TOWN OF SOUTHBURY, CONNECTICUT
ADDENDUM NO. 1
REPLACEMENT OF BRIDGE NO. 130-009 OLD FIELD ROAD
OVER BULLET HILL BROOK

Bid Opening: Friday March 21, 2025
@ 10:00 AM

**TOWN OF SOUTHURY, CONNECTICUT
REPLACEMENT OF BRIDGE NO. 130-009
OLD FIELD ROAD OVER BULLET HILL BROOK**

Meeting Minutes

REPLACEMENT OF OLD FIELD ROAD CULVERT
 OVER BULLET HILL BROOK
 SOUTHBURY, CONNECTICUT
 CULVERT MISCELLANEOUS DETAILS

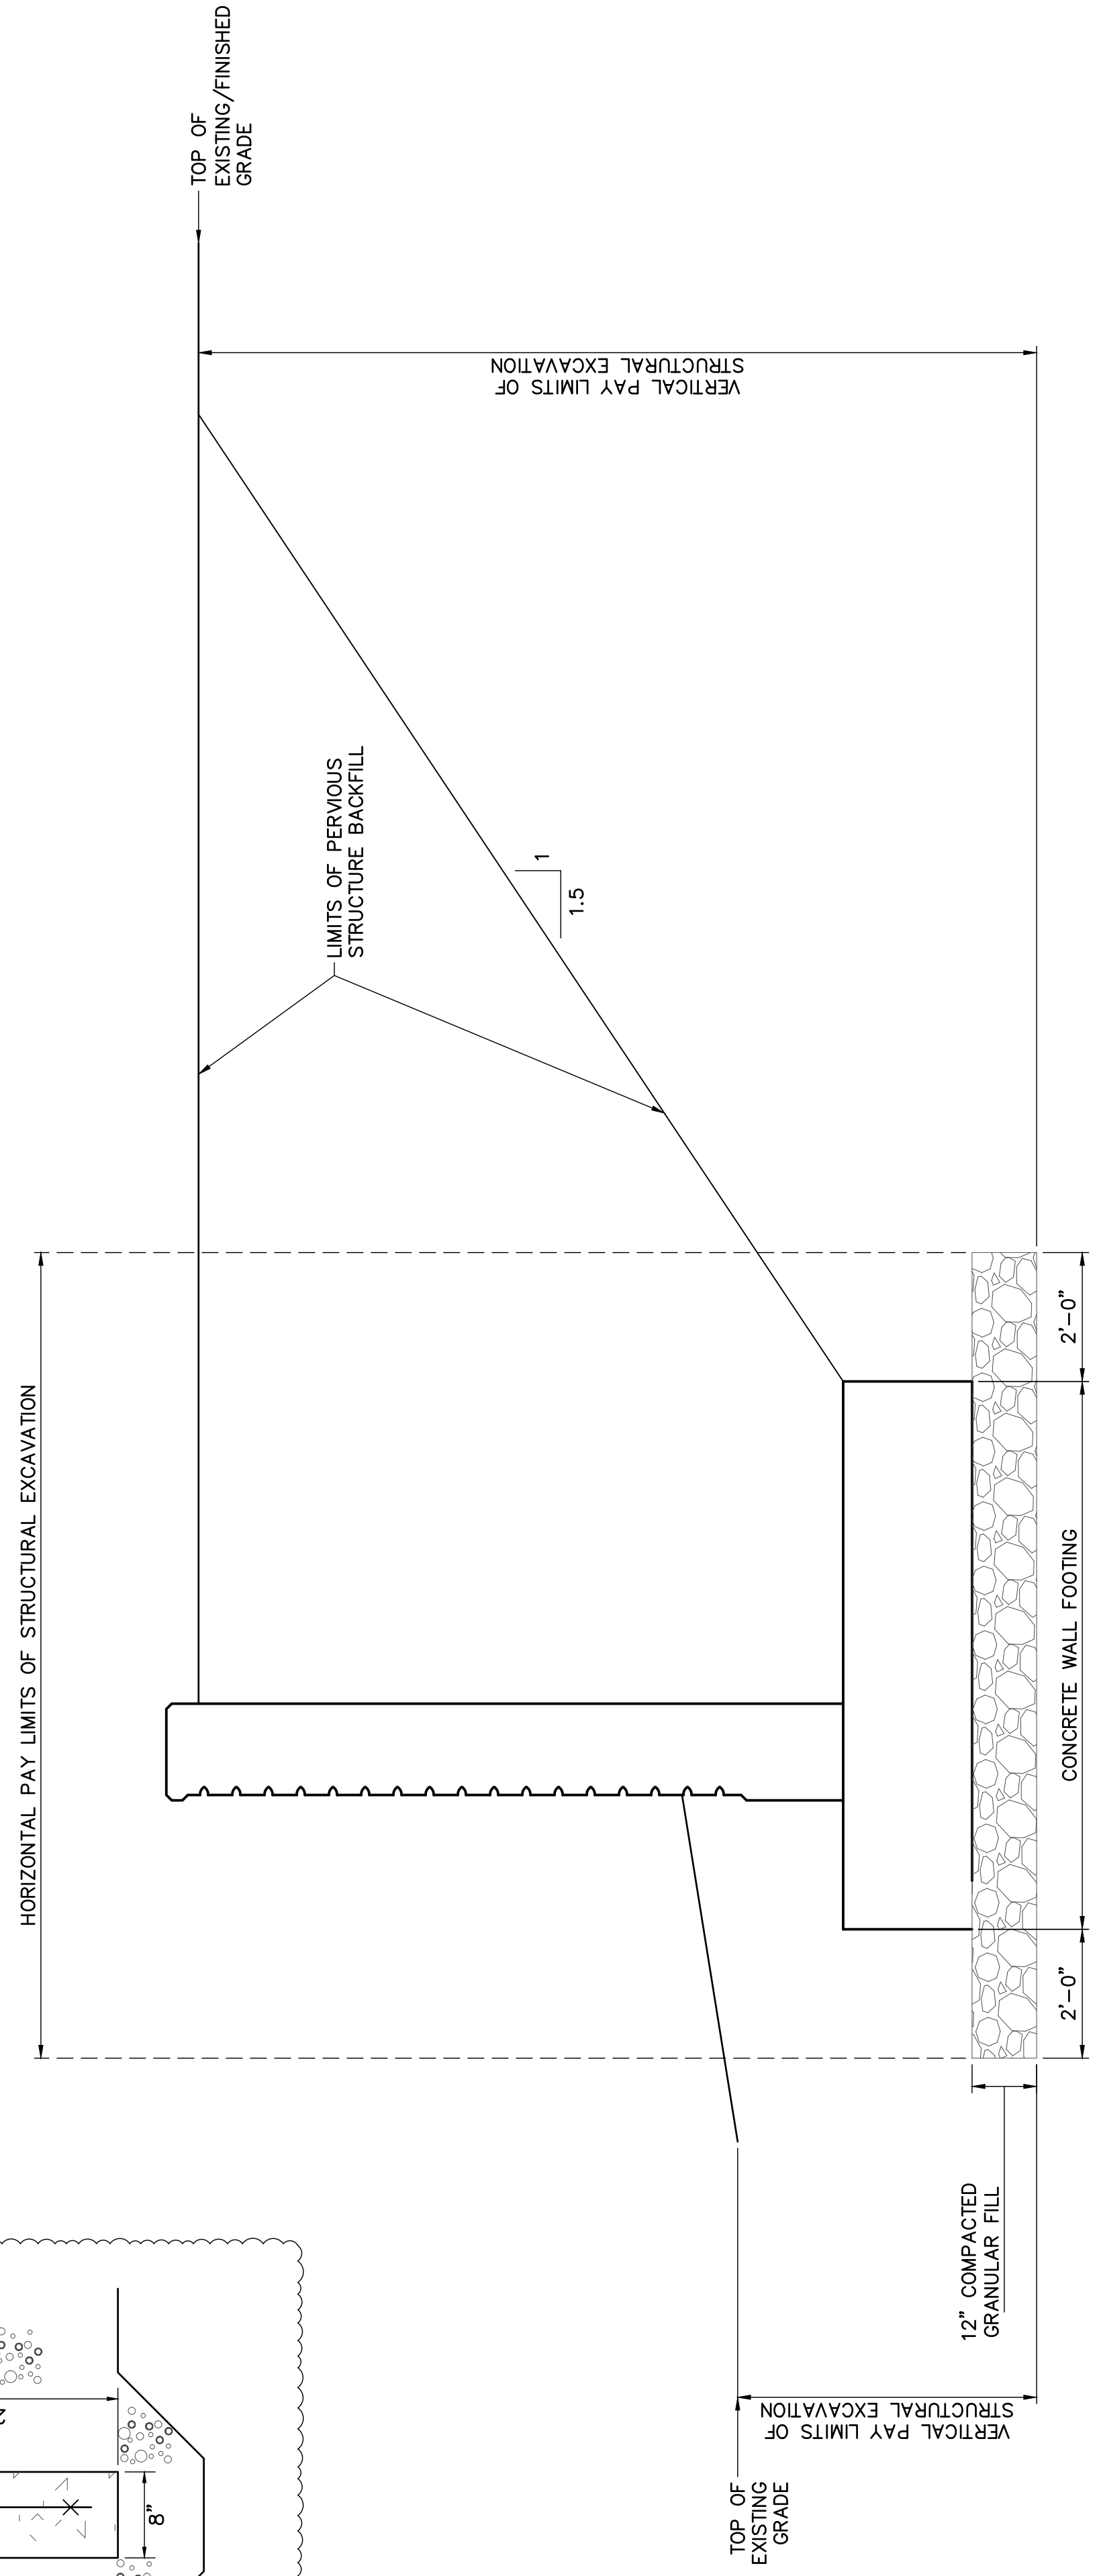
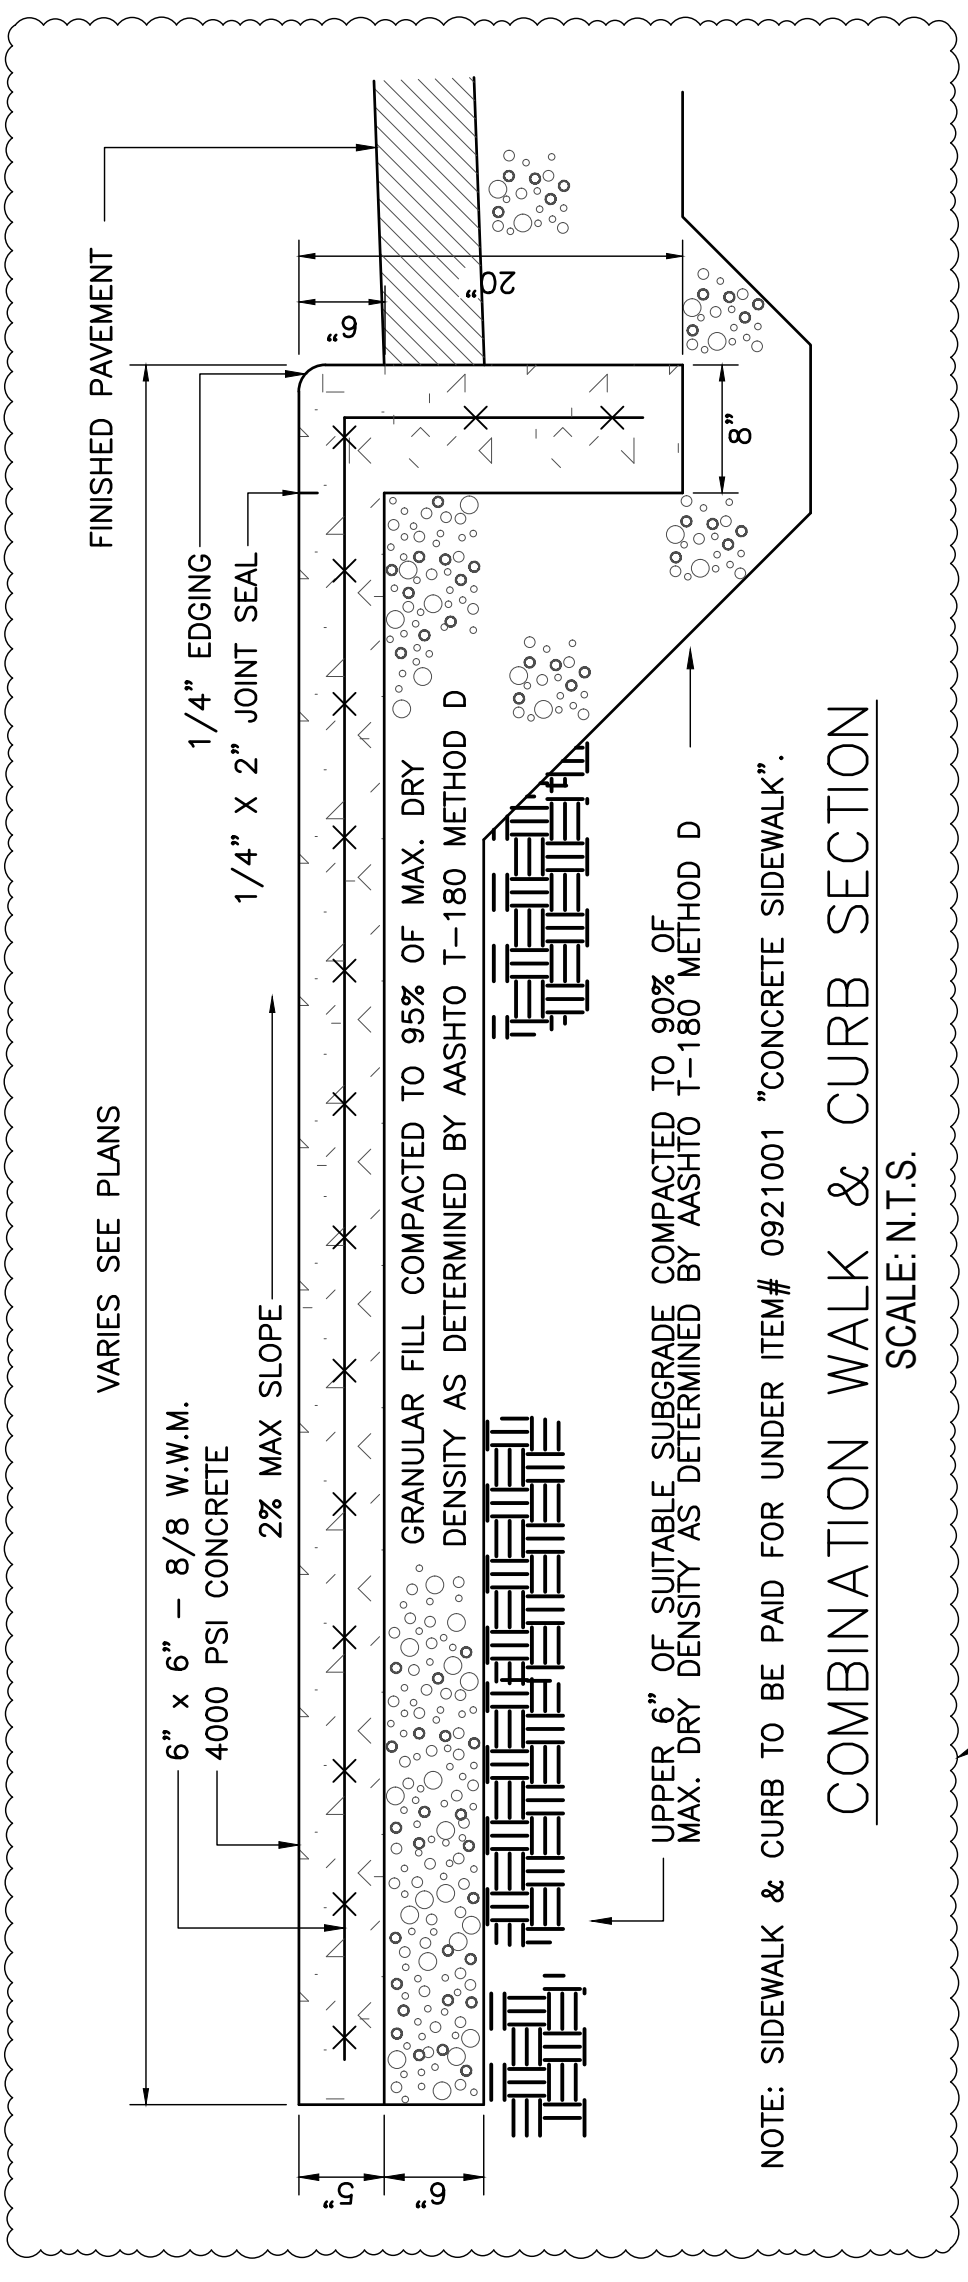
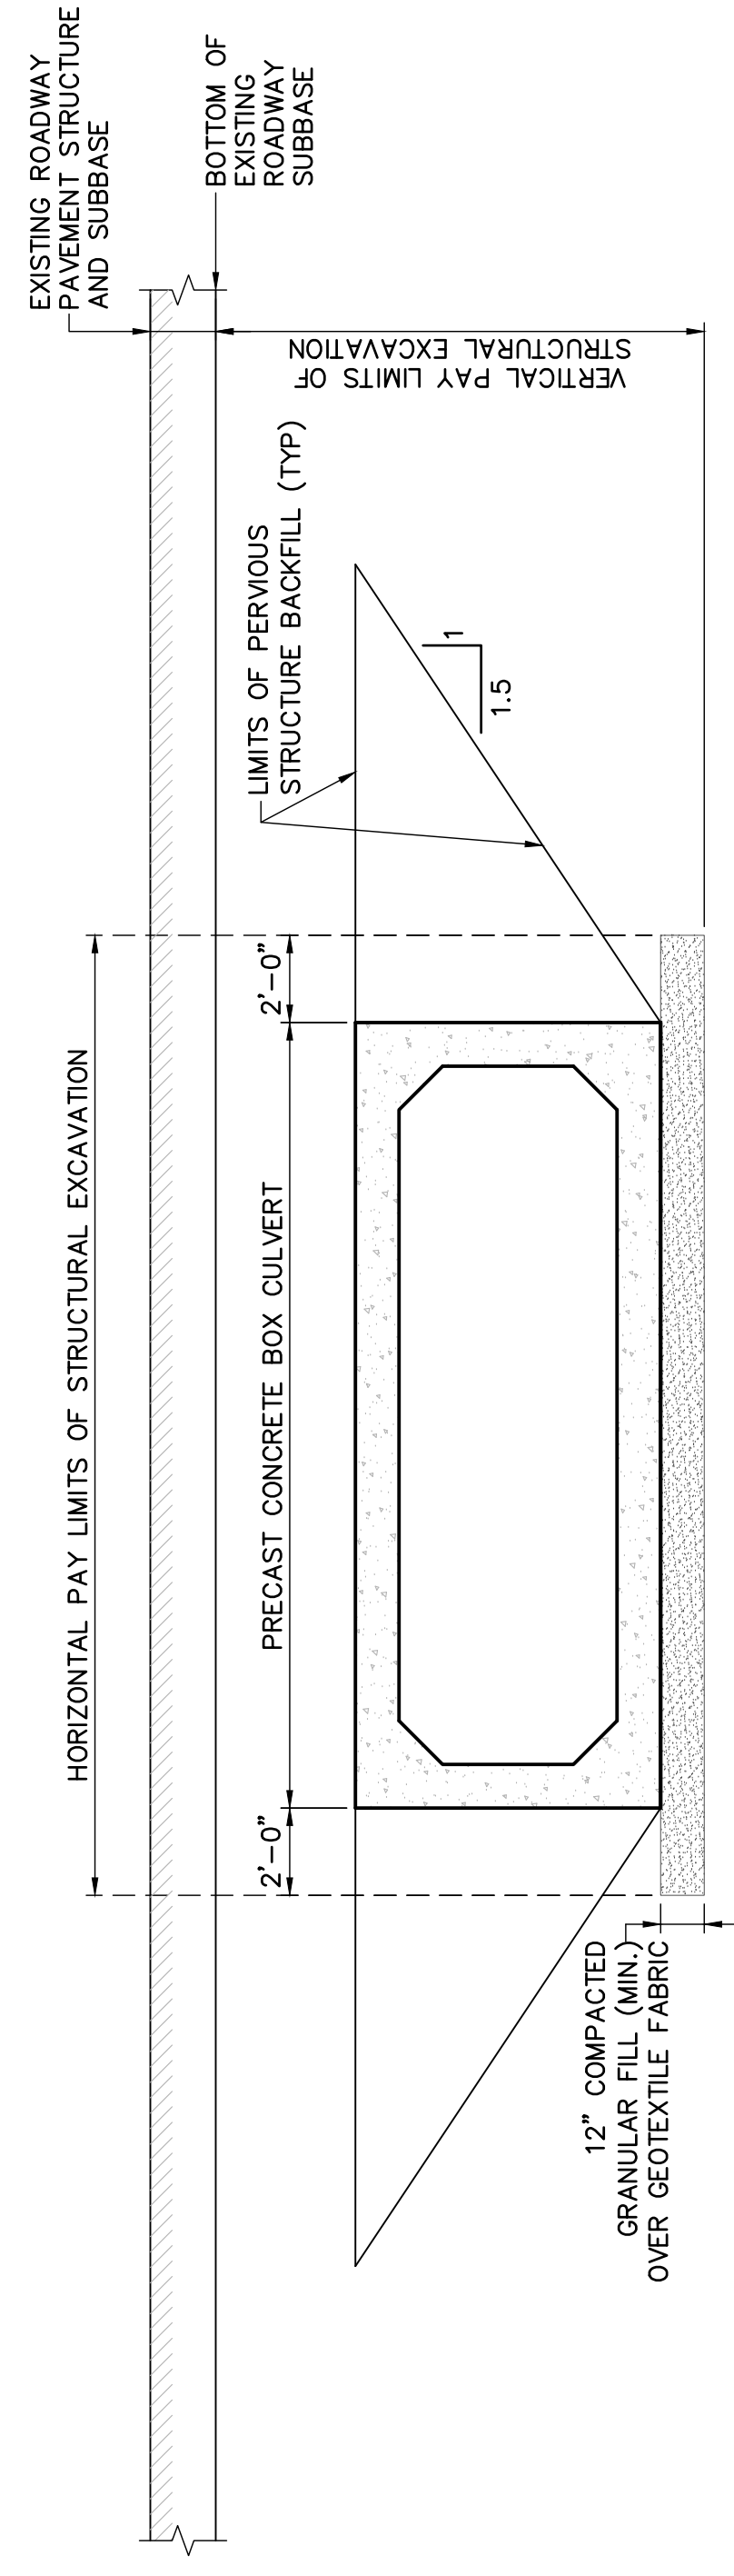
16. **Q** How is Concrete sidewalk (3 cy) over the box Culvert paid?
A Item # 0921001 Concrete Sidewalk added– see revised bid sheets – attached. See detail on revised sheet STR-10 A1.

6. Other items discussed:
1. Sidewalk will be cast with integral curb – detail attached.

NO.	REVISION	DATE	BY
1	DETAIL ADDED	03/17/2025	CAD
